### **ITEM FOR ENVIRONMENTAL COMMISSION AGENDA**

**NAME & NUMBER OF PROJECT:** Stillwater - Double Creek Phase 2 | SP-2021-0178C

**REQUEST:** Variance request is as follows:  
Request to vary from LDC 25-8-261 to allow development in the critical water quality zone.

Development Services Department  
Staff Recommendations Concerning Required Findings

CONSPAN O SERIES O633 - 33'-0" X 6'-4"  
MALONE WHEELER CHANNEL CROSSING

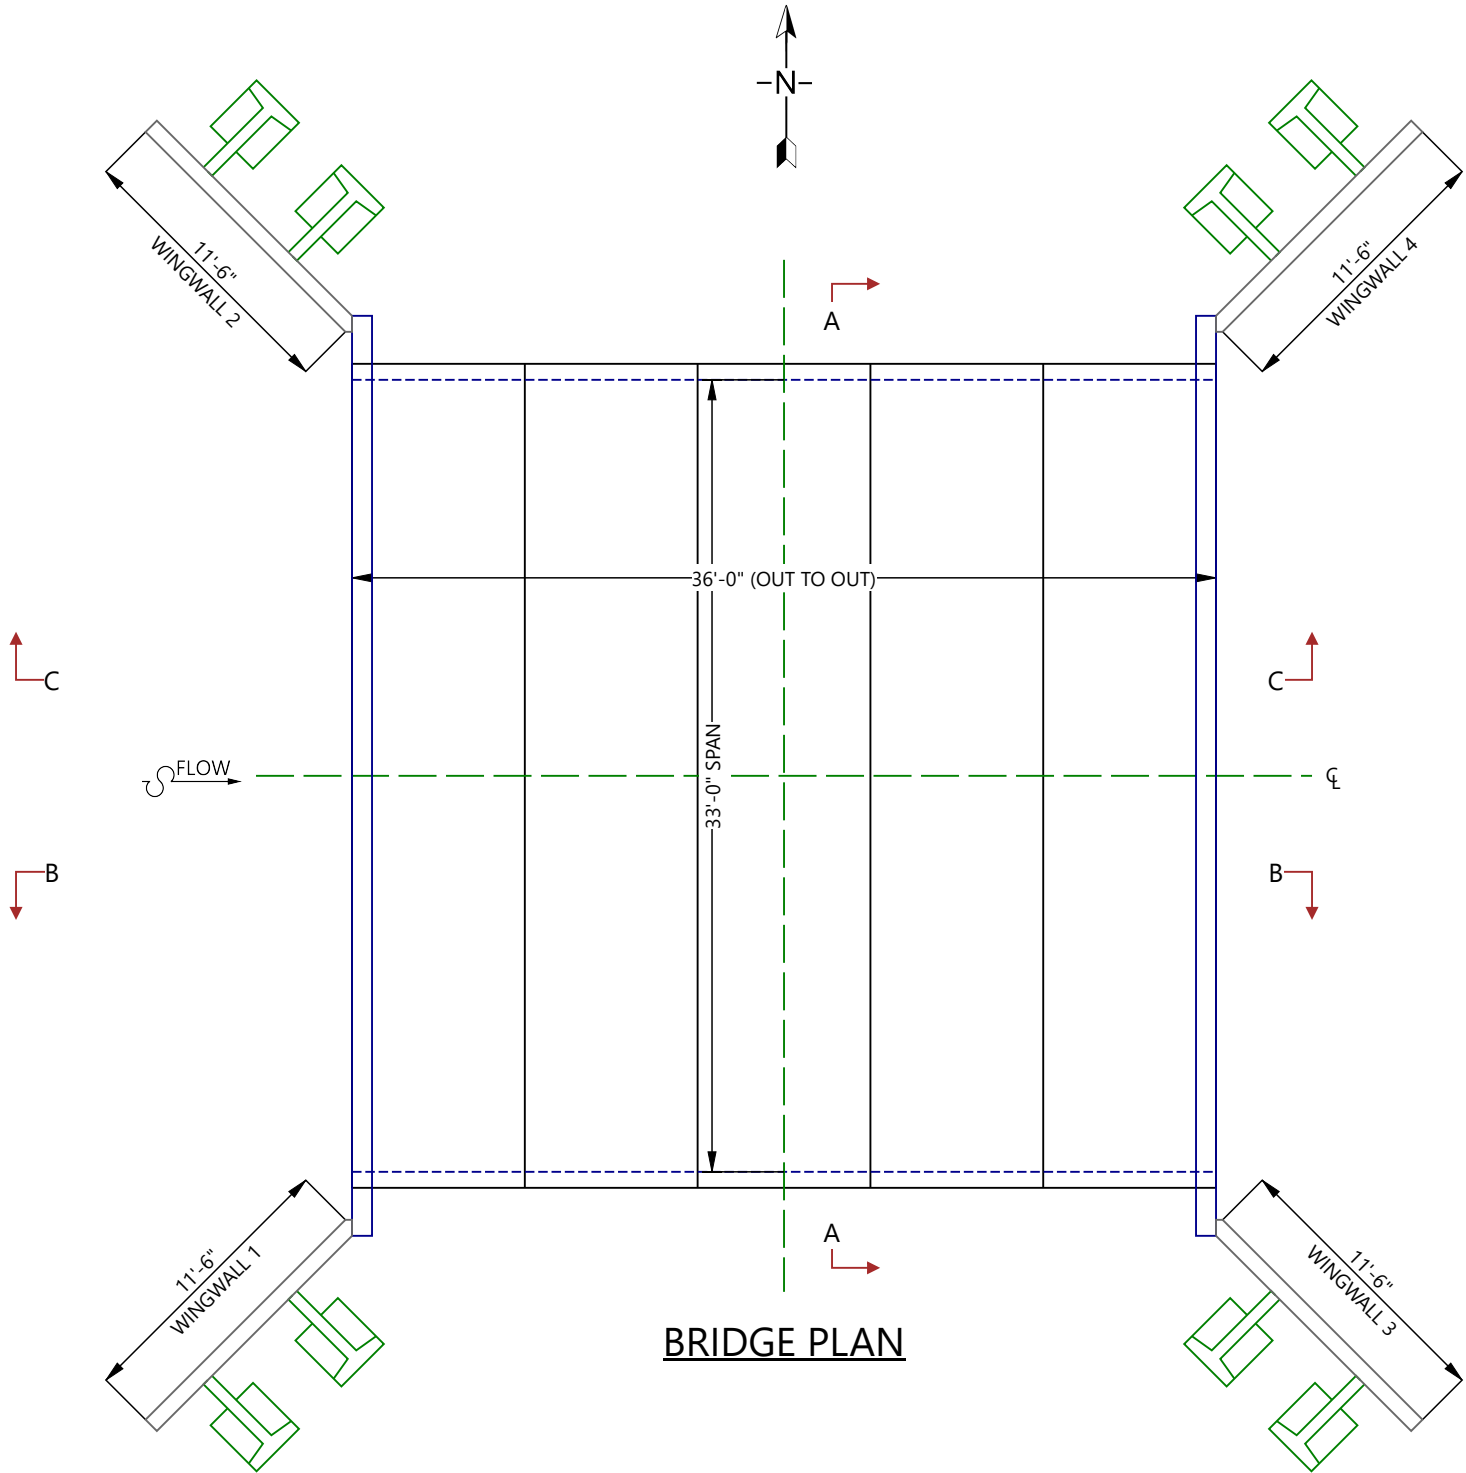
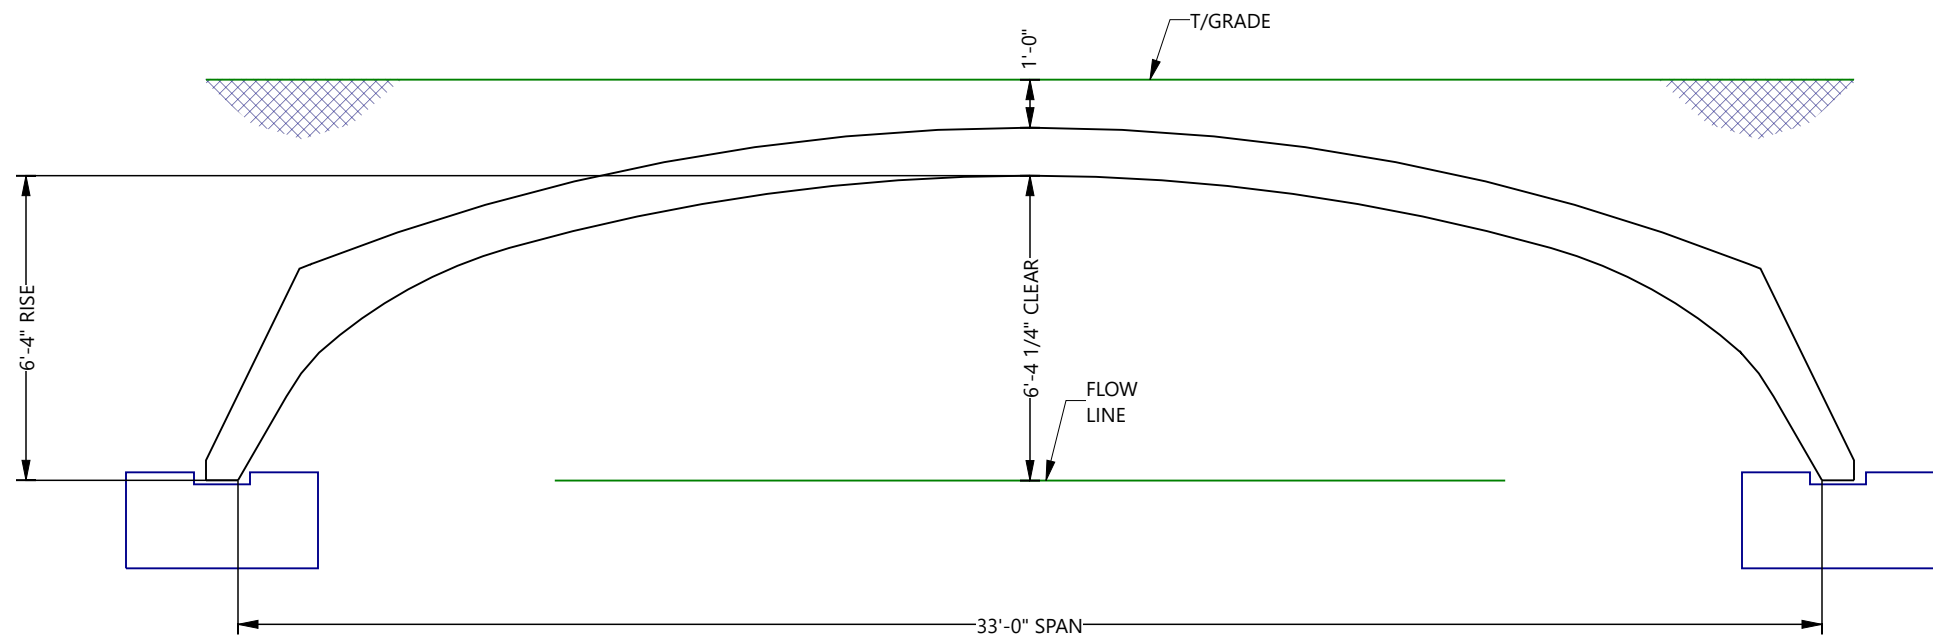
**Yes** The proposed improvements related to the variance do not create a significant probability of harmful environmental consequences. The CWQZ will be crossed by a span bridge design instead of the normal box culvert. This will allow for light to penetrate to the natural ground surface and for vegetation to grow thus maintaining a more natural stream channel.

- to decrease overall impervious cover and increase stormwater infiltration onsite and baseflow in the stream channel.
- 2) The critical water quality zone will be crossed with a span bridge design instead of the normal box culvert. This will allow for light to penetrate to the natural ground surface and for vegetation to grow thus maintaining a more natural stream channel.
